# 1014 — Space For Ideas

## Community board 8 hearing

Certificate of Appropriateness Application  
no. #M00746664-I1

# **Proposed amendments to approved design**

# Stair section

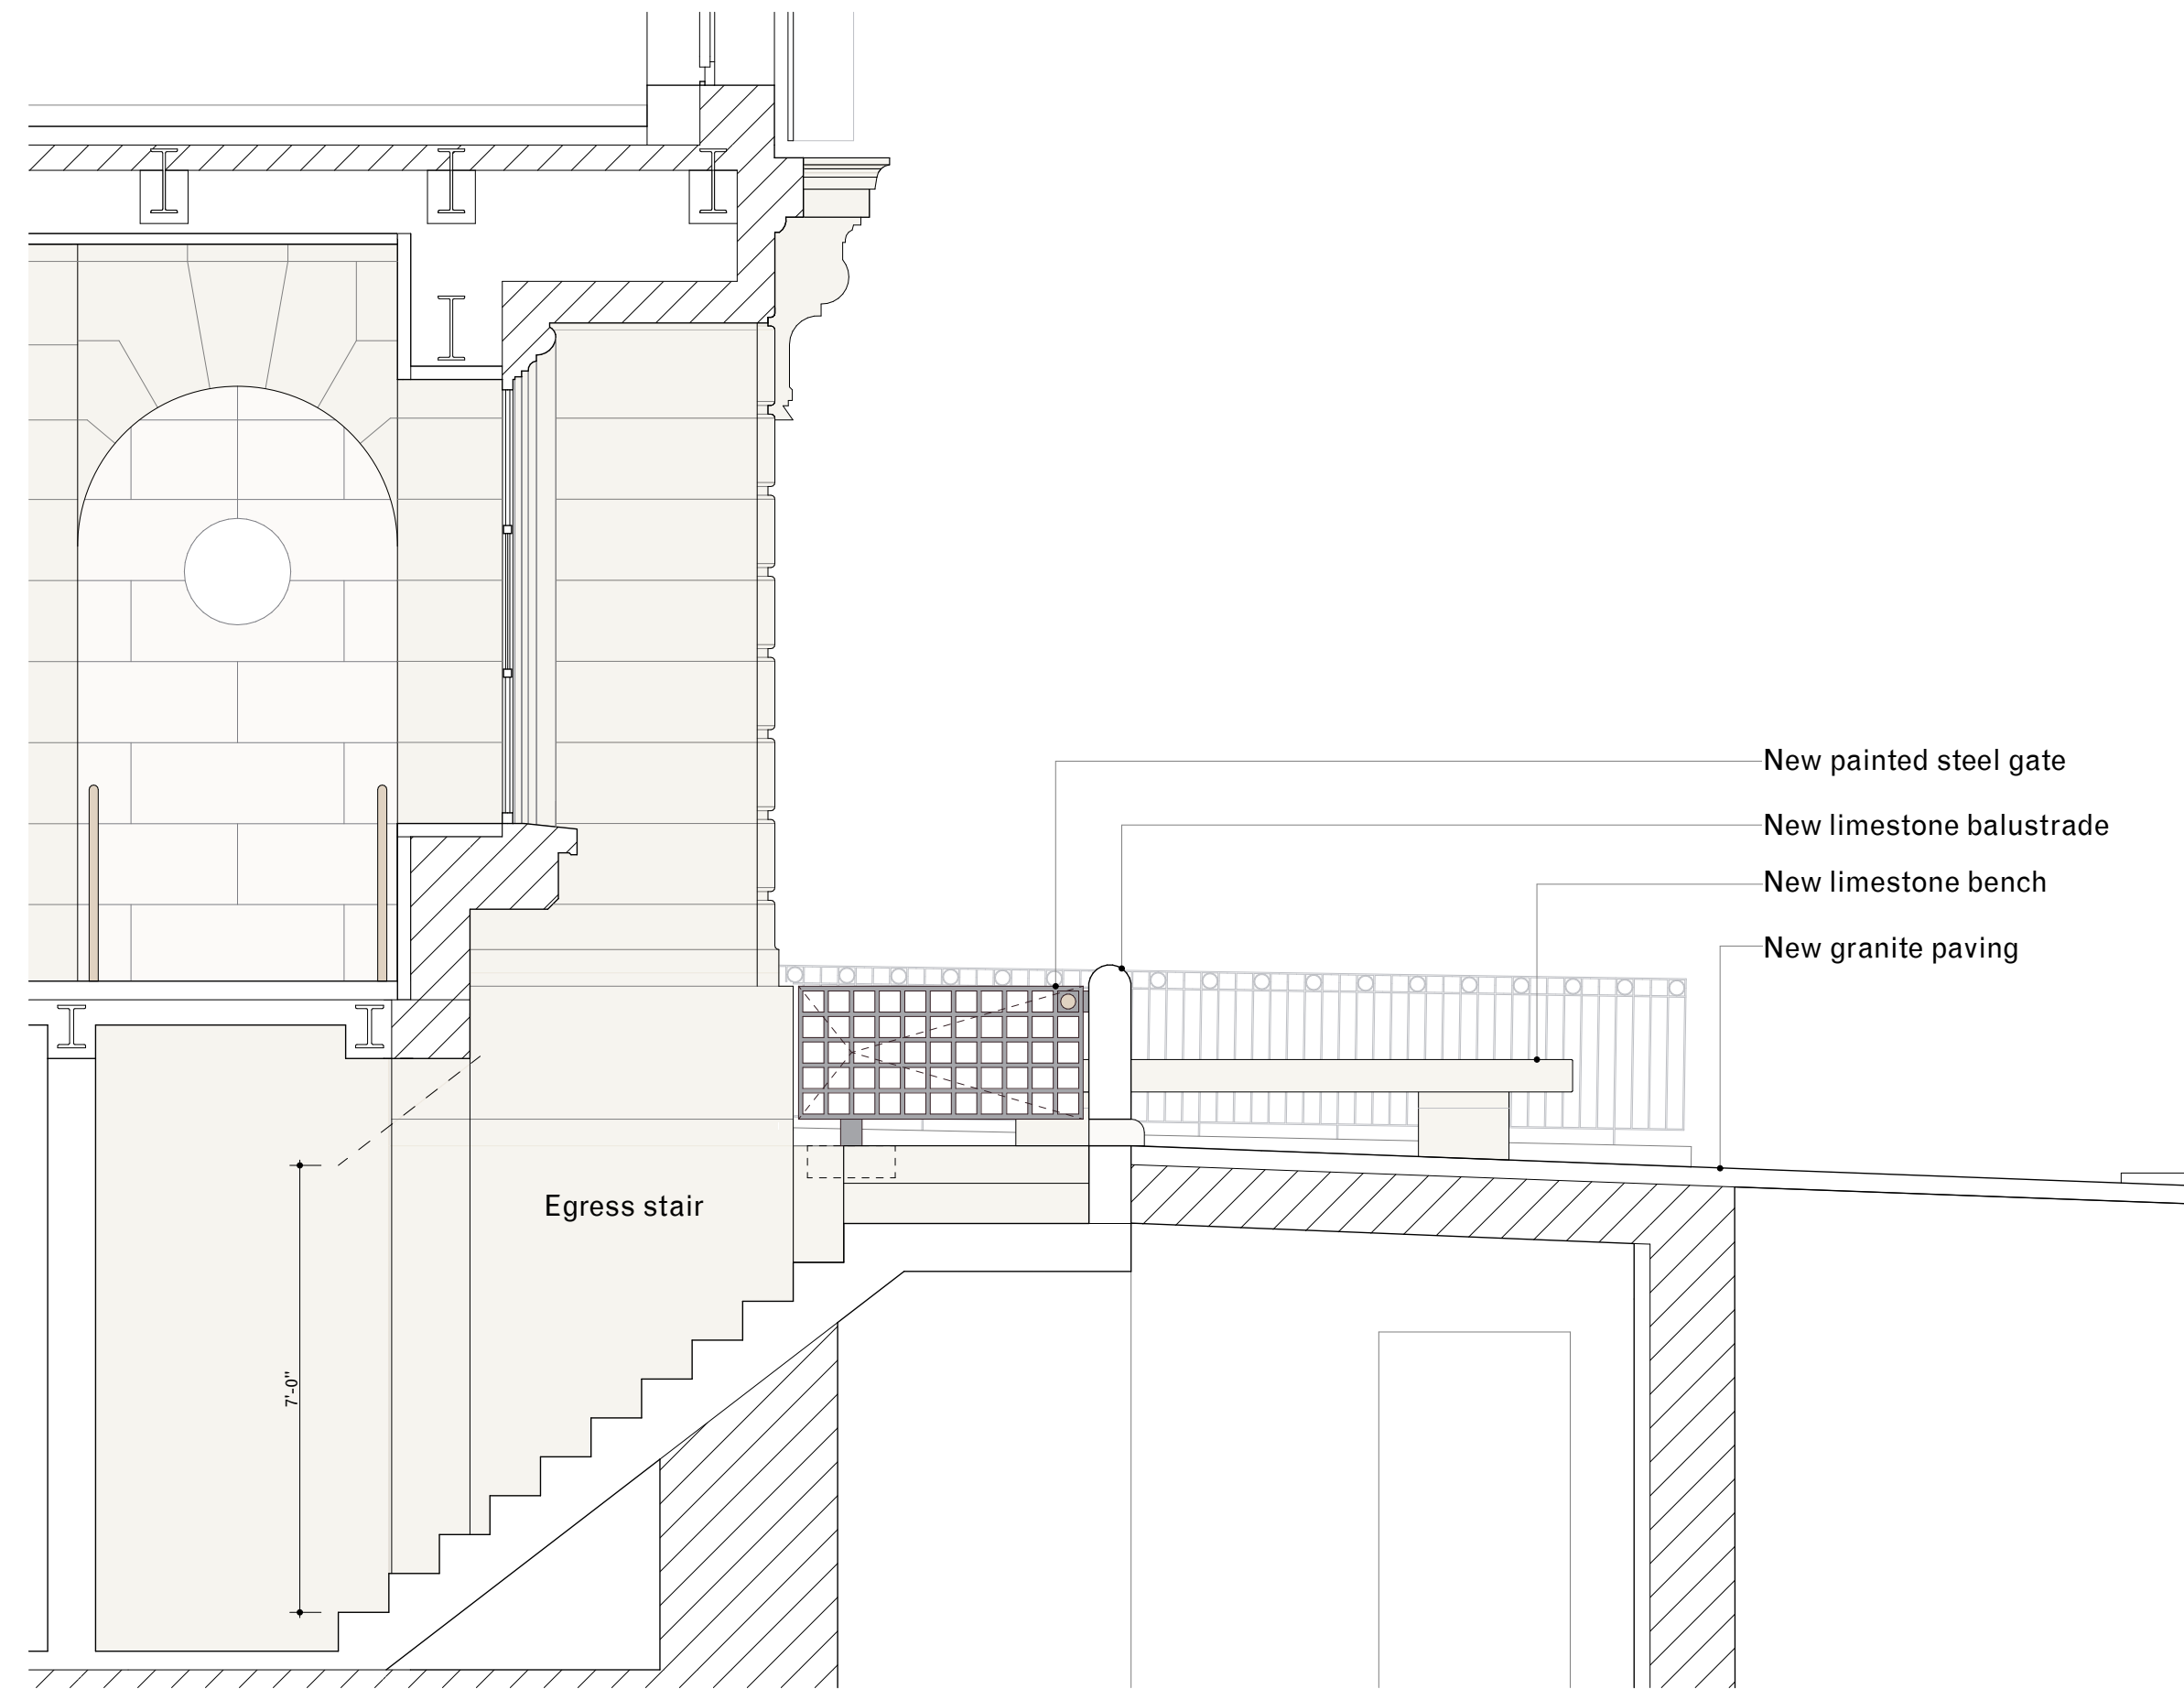
- New limestone balustrade subtly references rounded detailing of facade elements and rustication
- Stair pivot gate uses same language as entrance gate

- New stair uses existing lintel and provides sufficient clear head height
